Memo

| | Project: WRIA 35, Asotin and Alpowa Creek Hydrogeology Evaluation |

RE: Response to Comments by Ecology on Draft “Asotin Creek and Alpowa Creek Hydrogeology Report” Dated May 8, 2009

Page 2.4, Section 2.4 Seepage Run

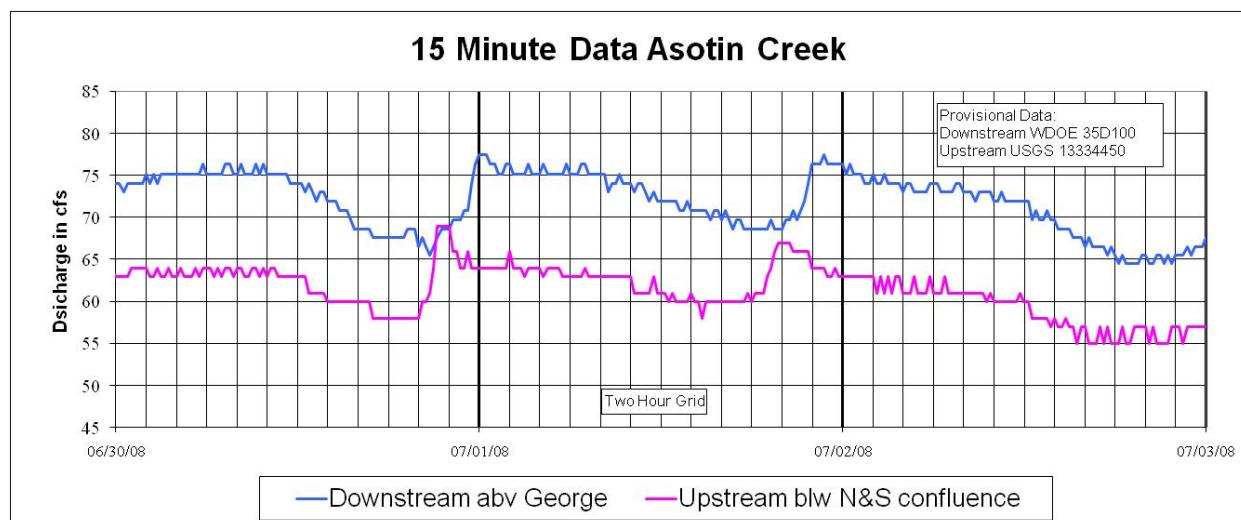
This section needs a new subsection that analyzes the available continuous flow gauge data. As discussed during our recent meeting, those data suggest significant diurnal fluctuations and this has direct bearing on the flow measurements made by HDR. For example, the data from two of the gauges are as follows:

As these data are for July when snowmelt is not a factor, they suggest diurnal changes due to ET losses from riparian vegetation. If HDR measured flow at sites successively lower within a system over the course of a day and ET losses increased over the same period, then gains in that particular stretch may be masked by the countering effects of these two variables. Analyzing continuous flow records and explaining what time of day particular measurements were made for the various stream reaches should shed light on this. Similarly the points on the graphs in figures 2-13, 2-15, 2-17 and 2-19 should list the time of day those measurements were taken.

See response to Comment 18.
